Official Transcript of Proceedings
NUCLEAR REGULATORY COMMISSION

Title: Advisory Committee on Reactor Safeguards
ESBWR Subcommittee: OPEN SESSION

Date: Tuesday, October 20, 2009

ESBWR DCD

ICS
Condenser
w/o support
structure

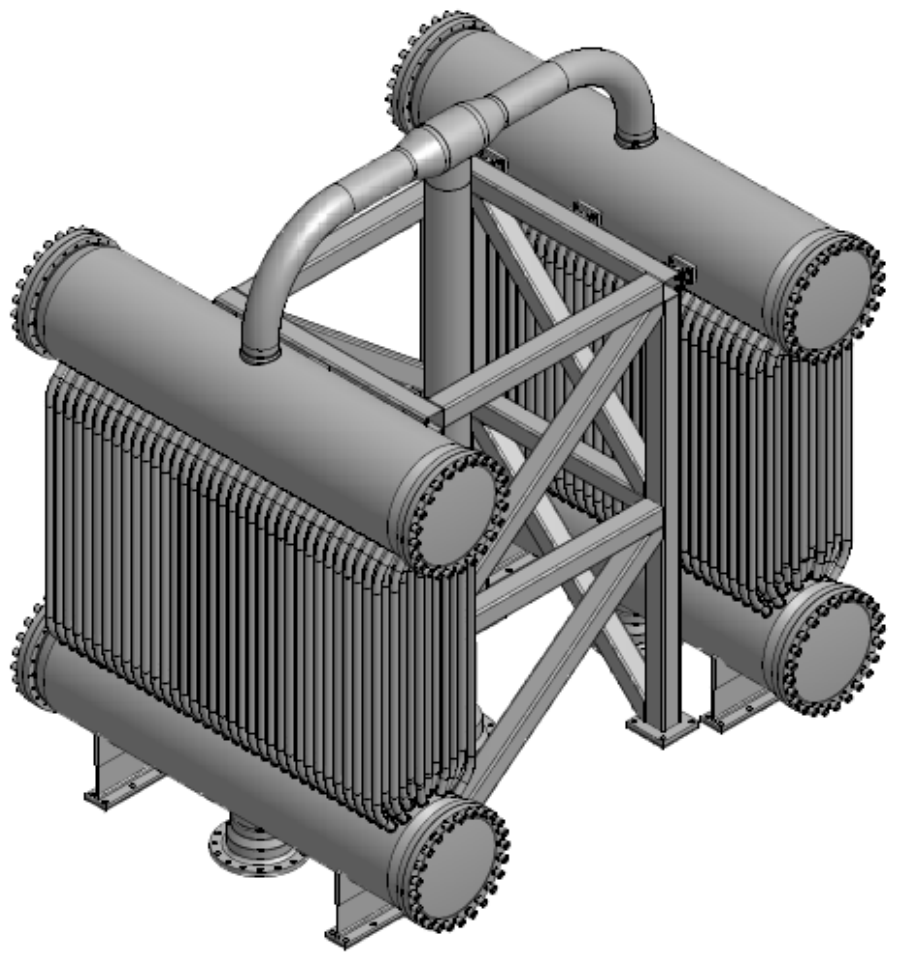
17 CHAIRMAN CORRADINI: Just one question now
18 about support. So is the support design for the PCCS
19 and the ICS identical and you show one with and one
20 without just for illustration purposes?

13 CONSULTANT WALLIS: Do you have a drawing
14 of the ICS like the PCCS which is more detailed that
15 we could look at?

16 This one here, the one in the previous
17 slide you show more detail than you do in this. And I
18 grant that schematics often depict the skeletons. So
19 I would like to see the real scale of the ICS with
20 details.

PCCS Condenser with
support structure

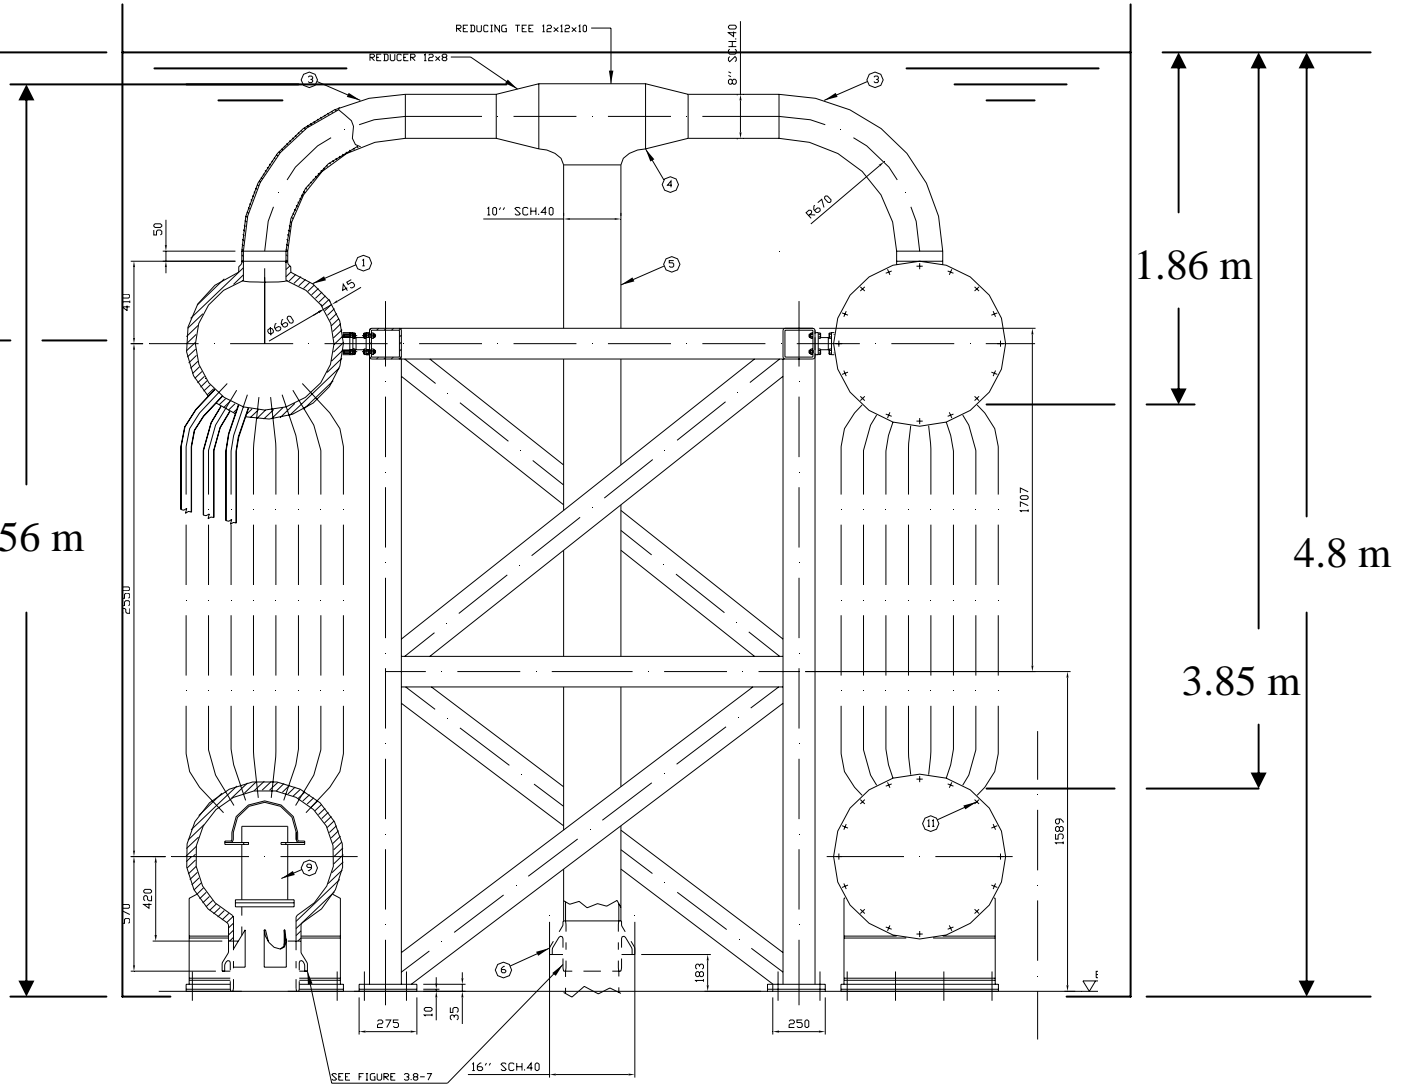
17 CONSULTANT WALLIS: And how close are the
18 tubes? That is the sort of question I wanted to get
19 the answer to. Will you be going on to that later on
20 sometime?

22 CONSULTANT WALLIS: So this branch from
23 the upper header to the wall is correct in the drawing
24 before this one?

1 CONSULTANT WALLIS: The distance from the
2 wall is correct?

21 CONSULTANT WALLIS: Well that is what you
22 say but until I see a drawing that is accurate, I
23 don't really know.

7 MR. DEAVER: The pool width is five meters
8 and the PCCS is about four meters, as I remember. So
9 there is some clearance to the wall. Part of that
10 clearance is actually shown in this figure.

Isolation Condenser Schematic

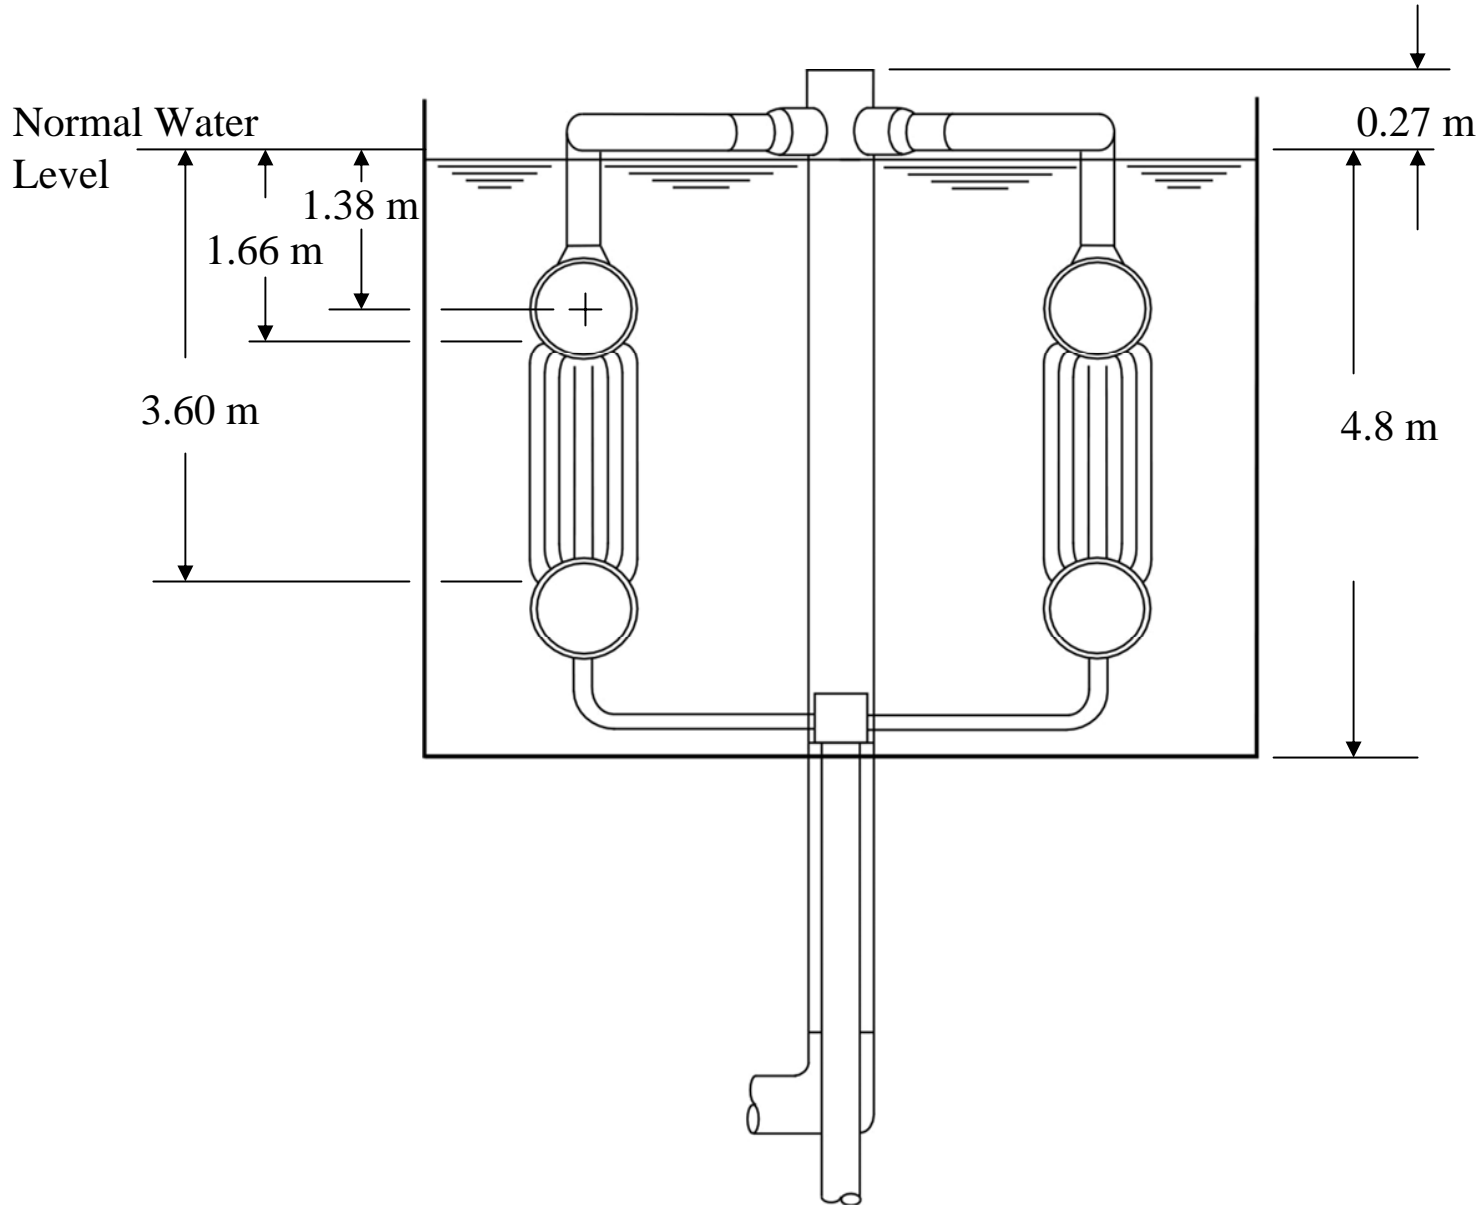
16 CONSULTANT WALLIS: Will you show where
17 the gas is collected in the isolation condenser?

3 CONSULTANT WALLIS: -- and then seven. Is
4 that the way it goes? The drawing says four.

18 CONSULTANT WALLIS: So what you are
19 saying, Rick, is that this figure is incorrect.

10 MR. WACHOWIAK: Right. And the
11 uncertainty in the level is where I was little bit
12 confused by the question because the system is
13 designed to operate with the water, all the way up to
14 the top of the cross pipes. And then with water
15 slowly progressing down all the way to the mid point
16 of the tubes. So under all those situations, it needs
17 to perform.

Stress Analysis of Pool Structures

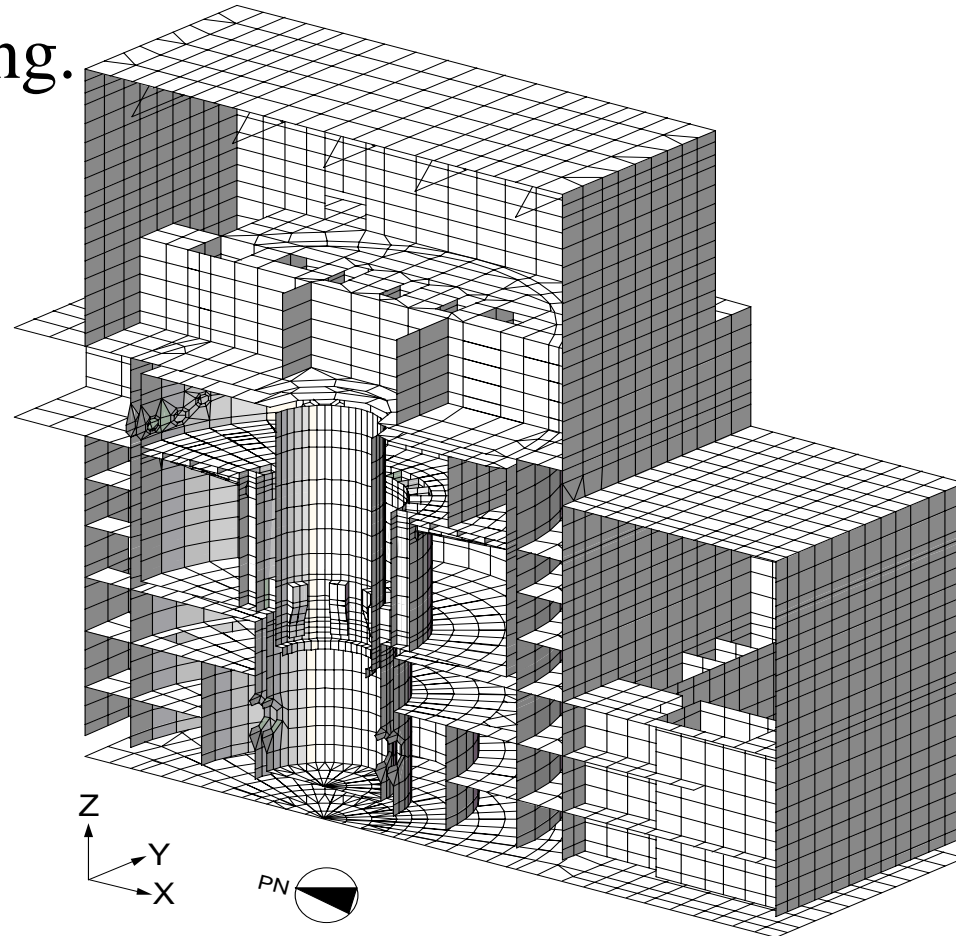
17 MEMBER ABDEL-KHALIK: On the previous
18 figure, is this the actual modelization they use in
19 the finite element analysis?

17 MEMBER ABDEL-KHALIK: Well my concern is
18 about the resolution of the mesh. I mean, this seems
19 like a very course mesh. And the question is whether
20 or not you actually checked whether the resolution of
21 the mesh is adequate.

2 MR. JENG: As to the question how do you
3 know how refined should be adequate? I think the
4 program is nearly built yet we check the convergence.

5 Okay? If they want to try and see that they converge
6 in a solution. If they don't converge, that means we
7 have to move on so we cut the size to half inch and
8 adjust until such a time your response is stable.
9 That defines how refined this mortar should be. It is
10 a basic technique available in that code technology.
